NEC® Code-Making Panel 11 First Draft Meeting Agenda

January 18 - 20, 2024

National Electrical Code®

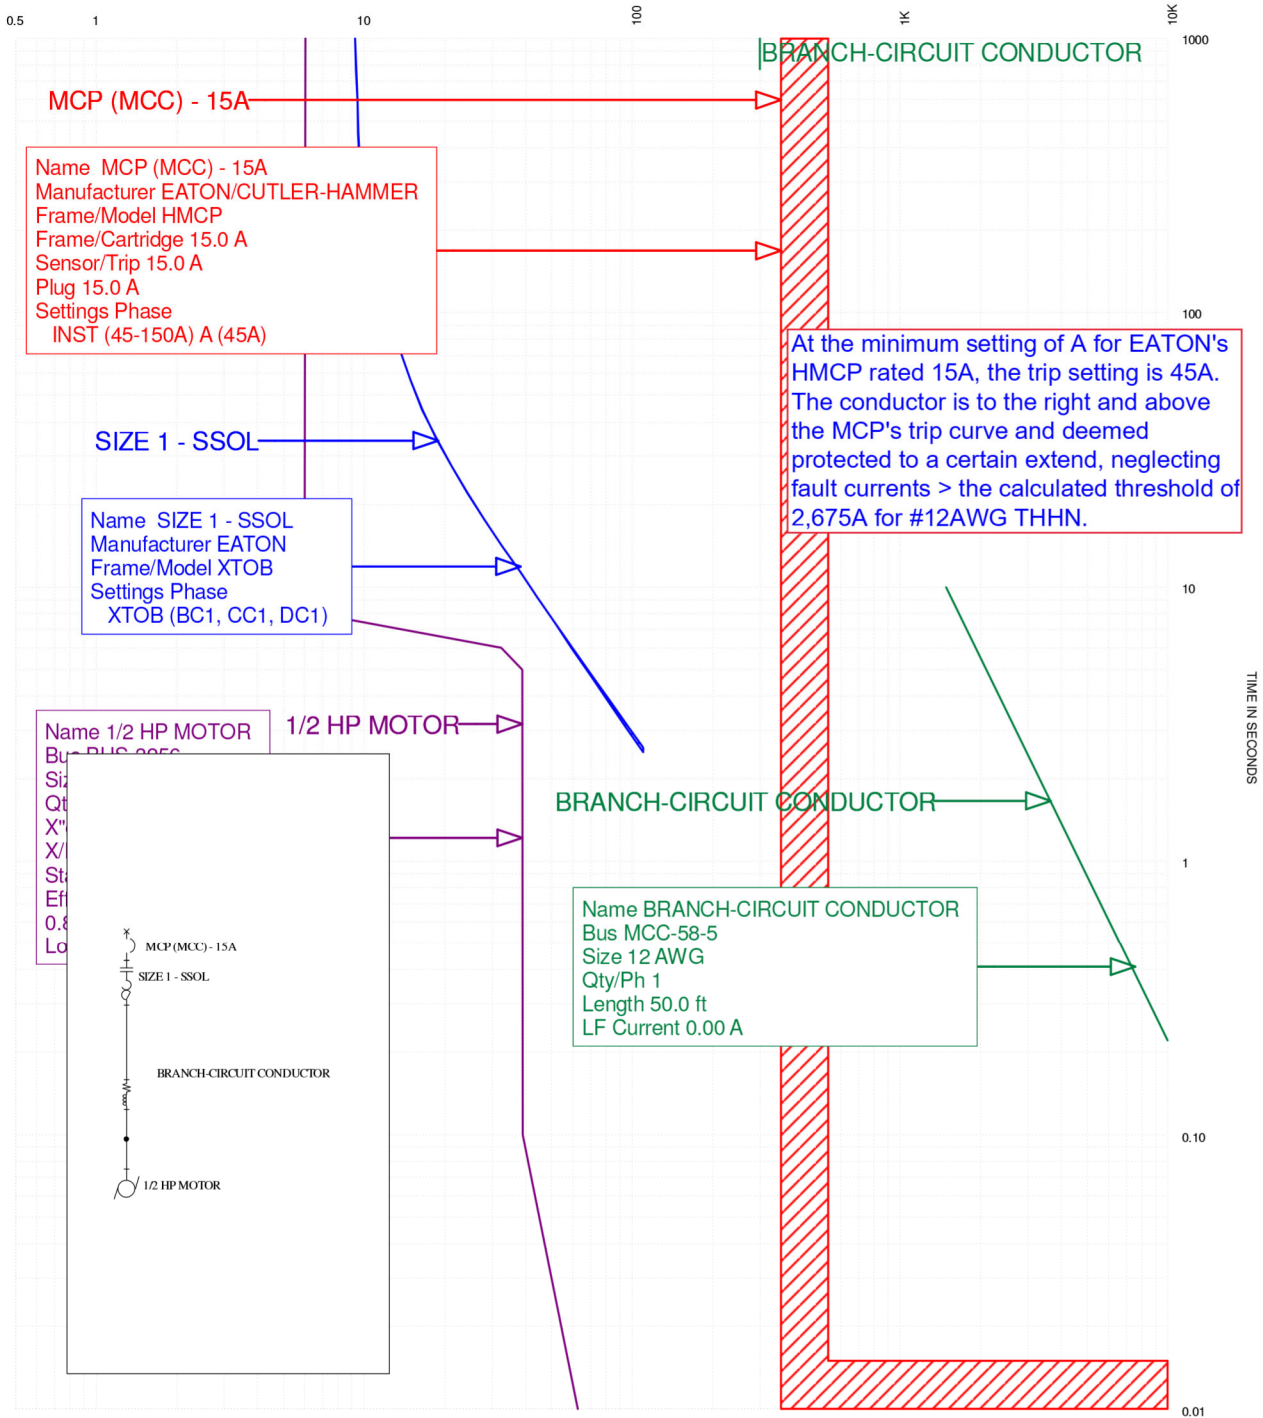
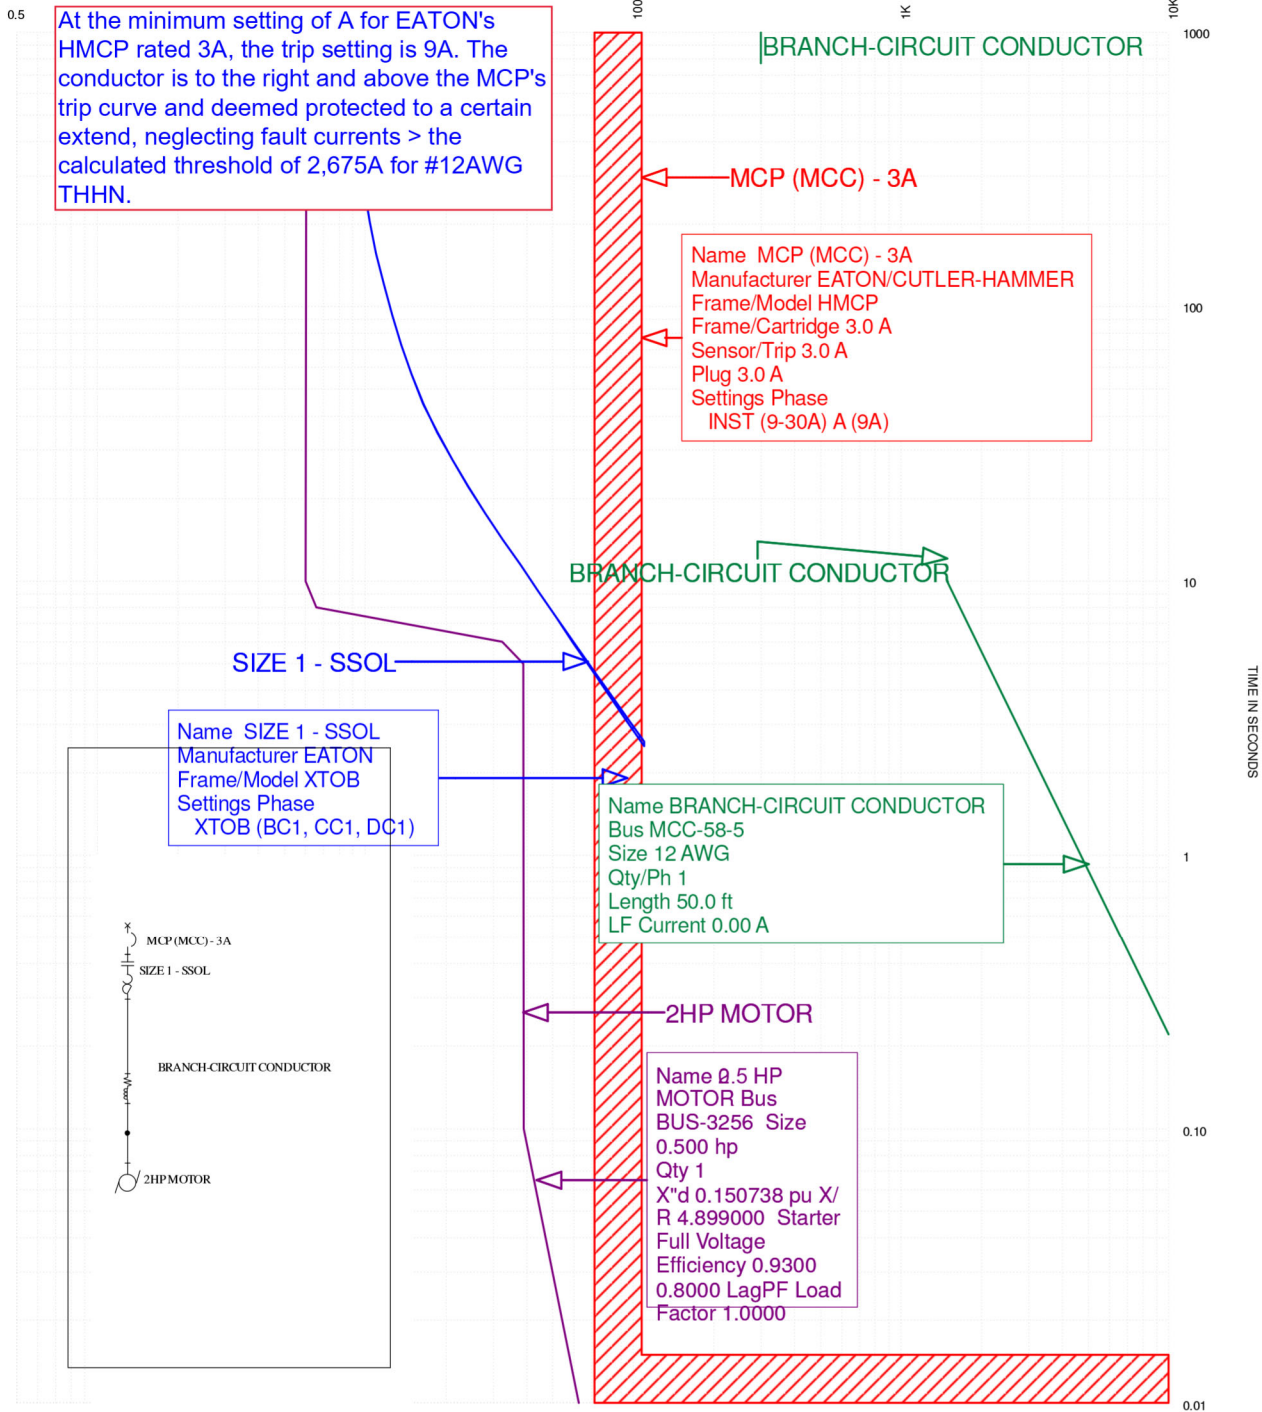
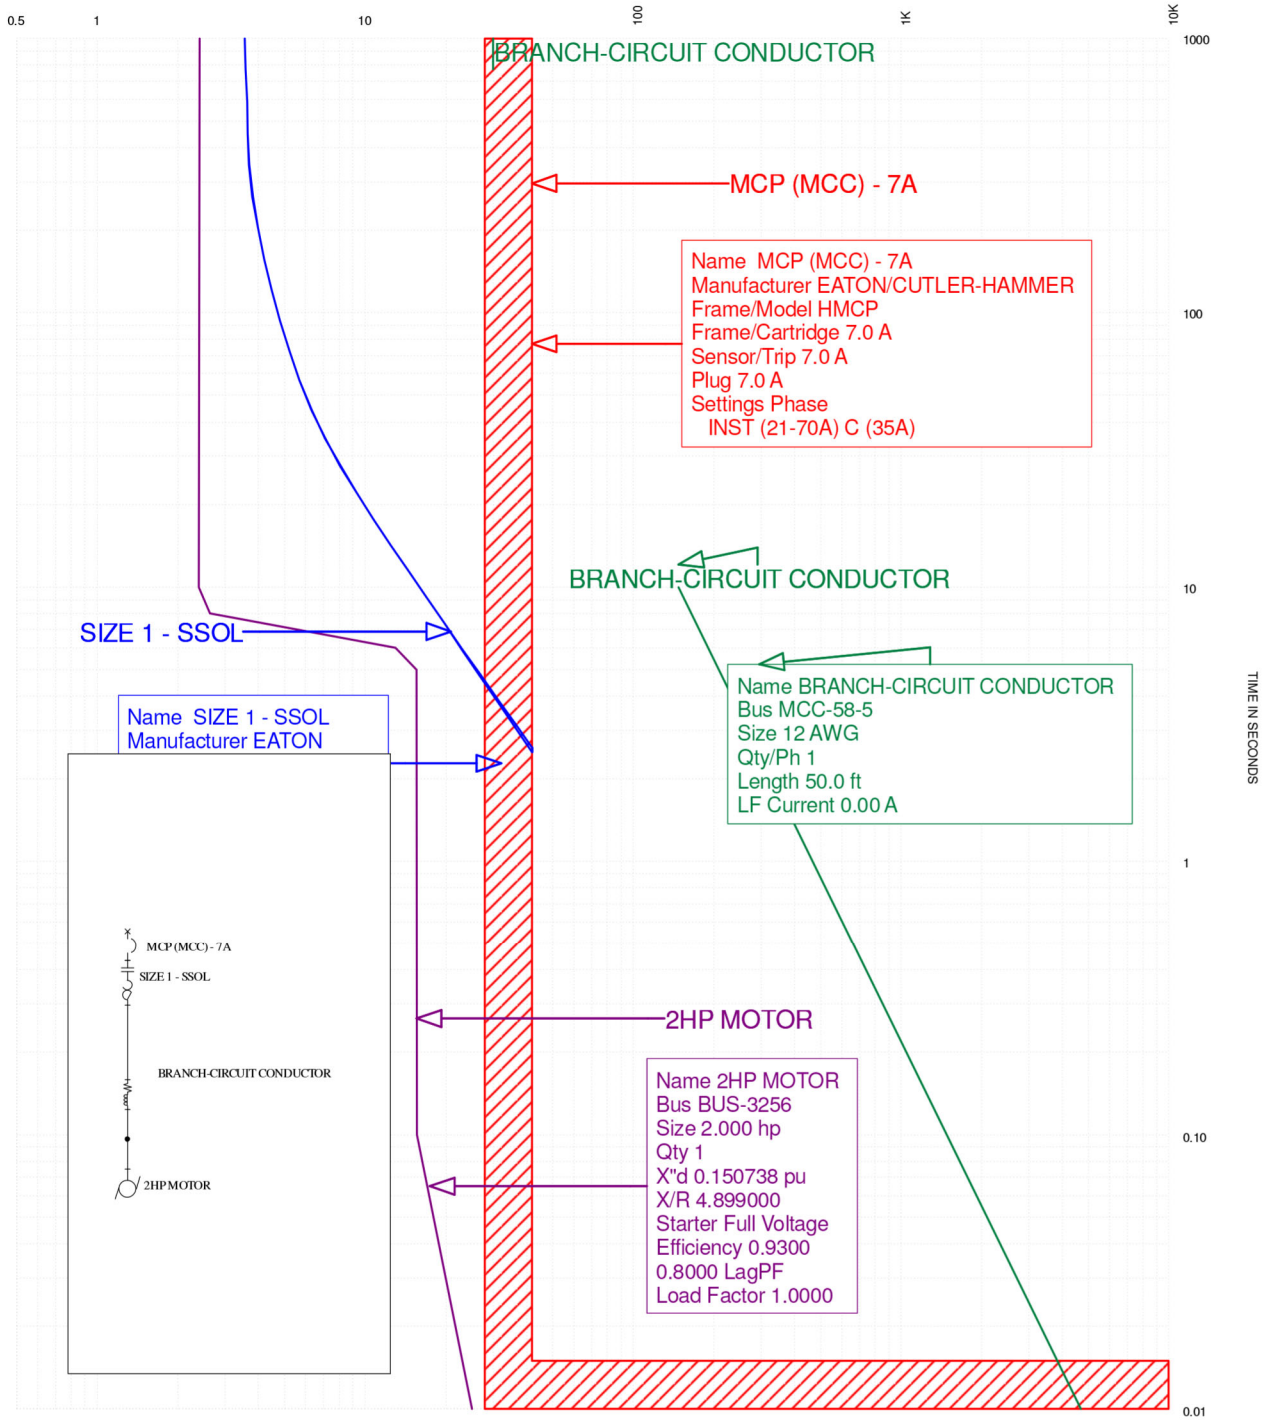
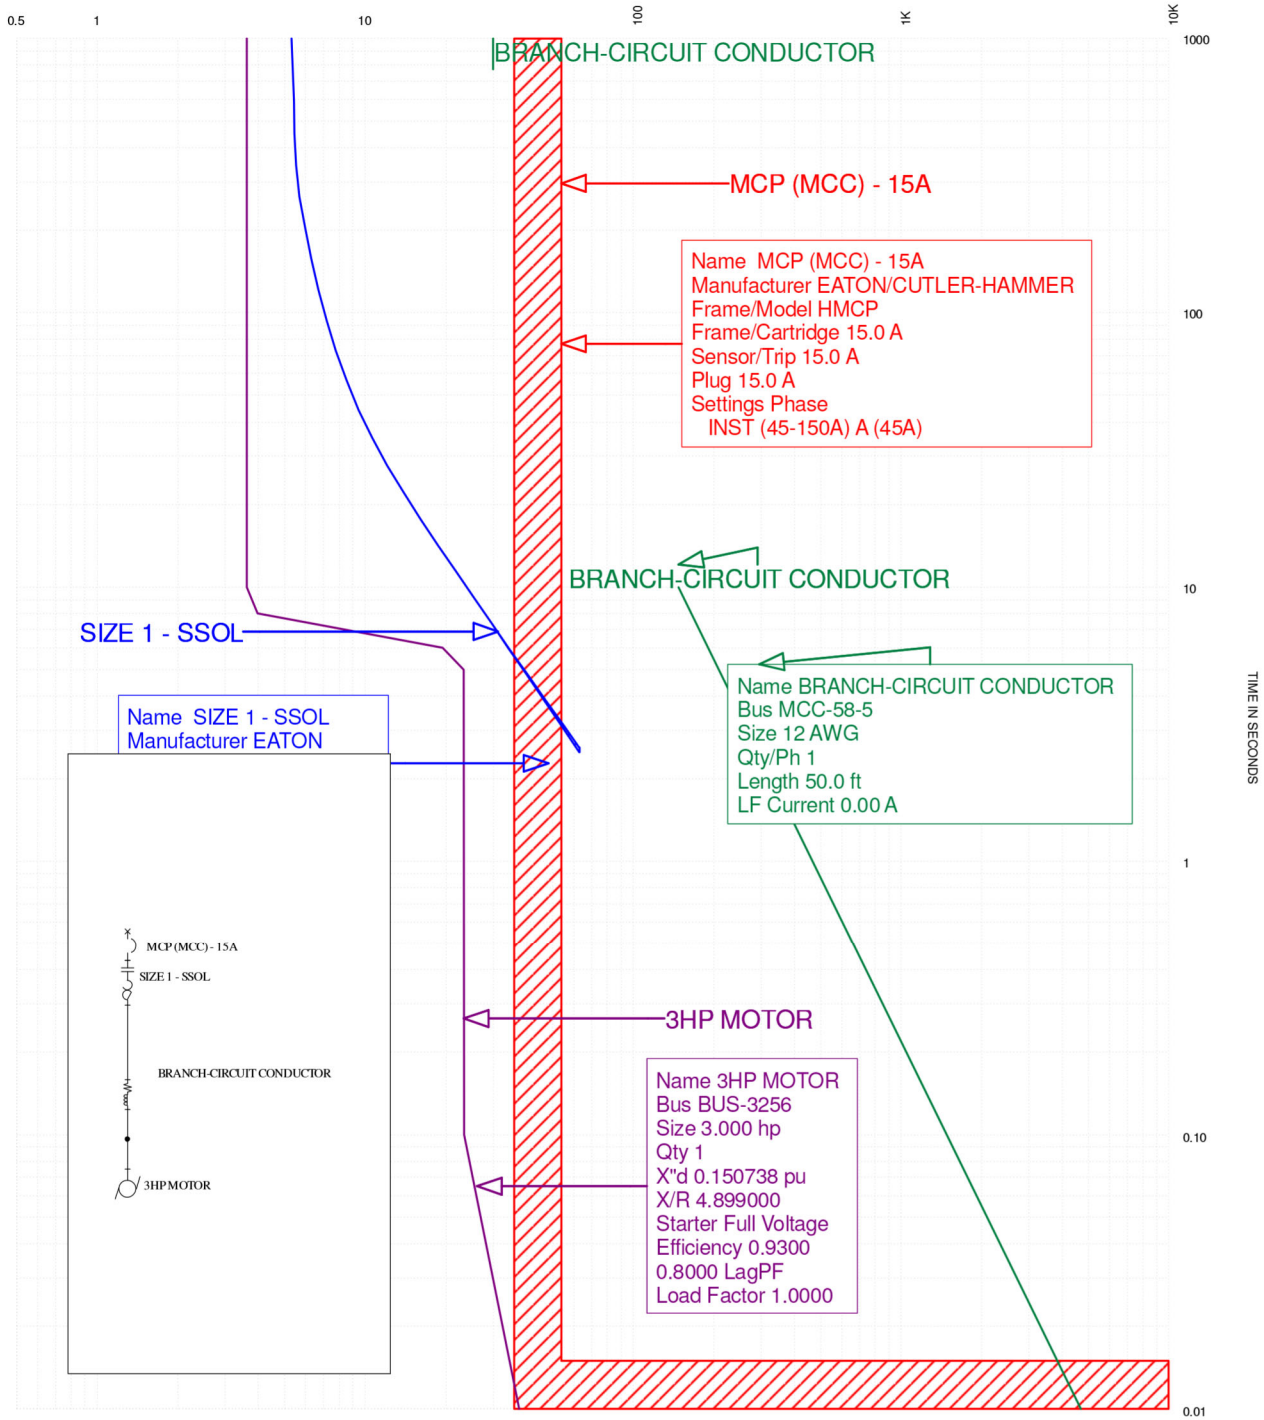
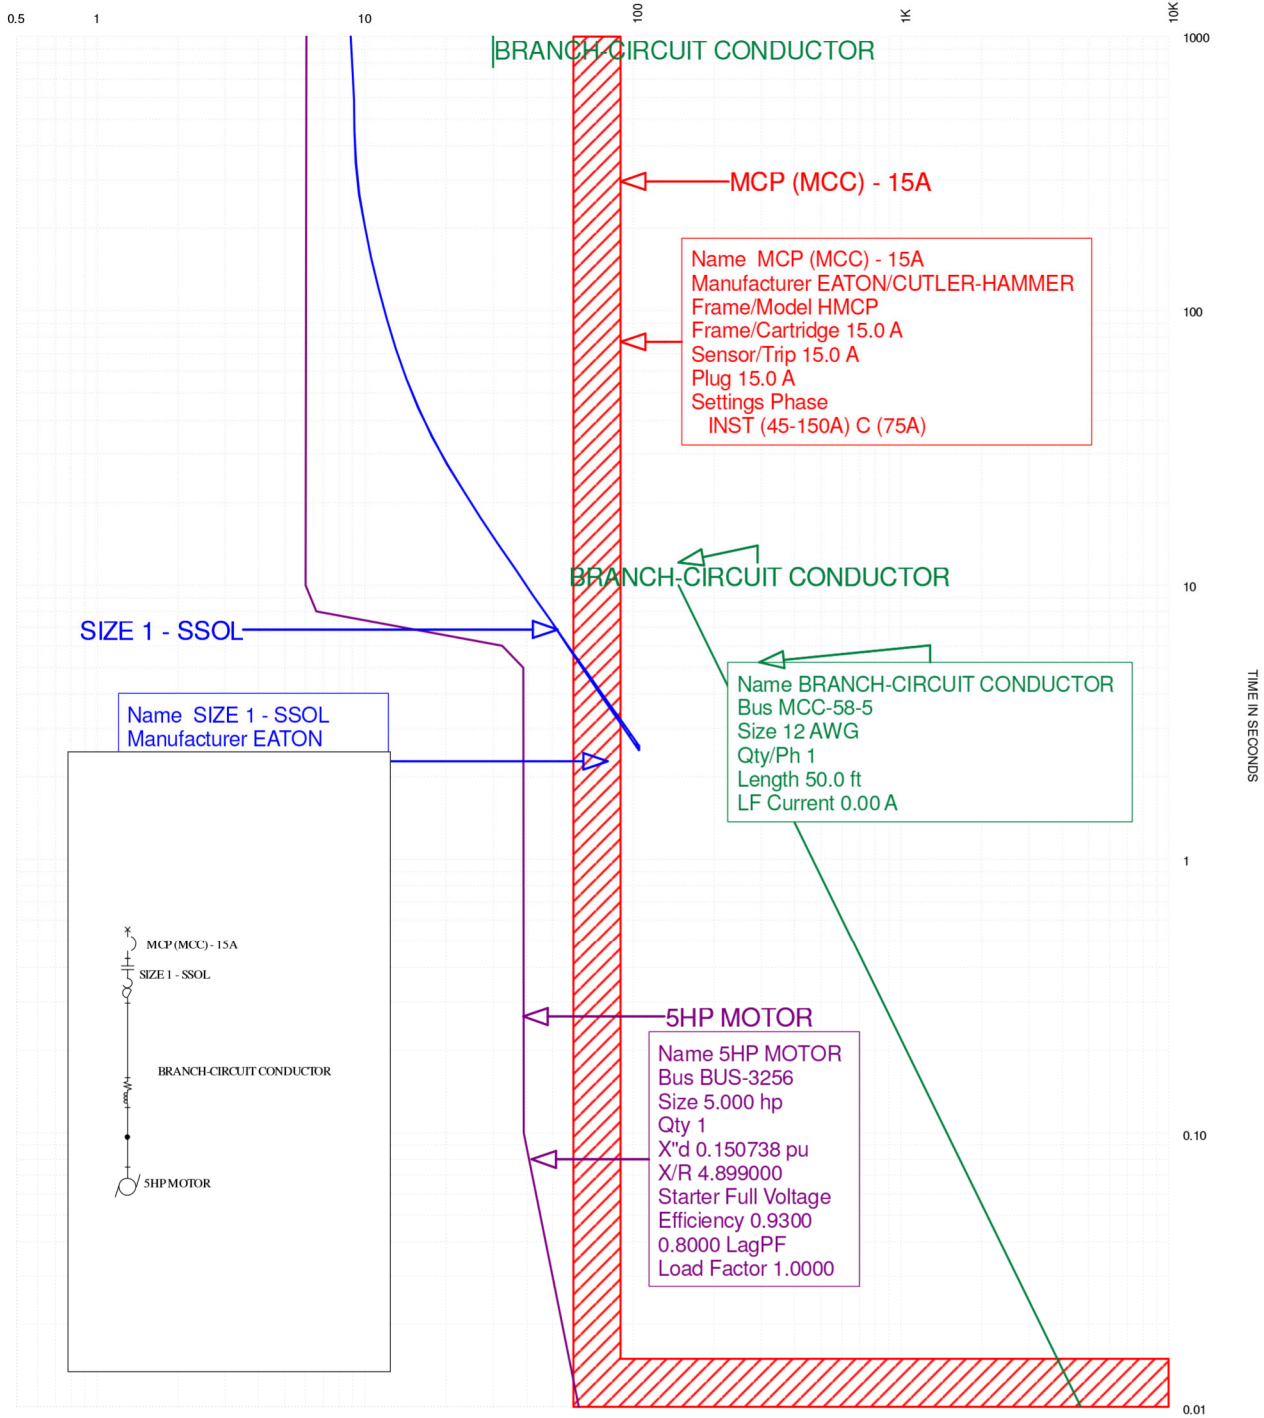
In 430.52(C)(3)(b)(2)a. of the 2023 National Electrical Code, a value of 1300 percent is specified for all motor types in Table 430.52(C)(1) other than Design B energy efficient and Design B premium efficiency. Since the introduction of Design BE and CE introduces a new exception to the 1300 percent specification, it is proposed to specify a value for each of the motor types shown in Table 430.52(C)(1) instead of specifying a single value with a list of exceptions. This does not change the adjustable instantaneous-trip setting specified in 430.52(C)(3)(b)(2) of the 2023 National Electrical Code for any motor type with the exception of the Design BE and CE, energy-efficient Design C, and premium efficiency Design C motor types already mentioned.
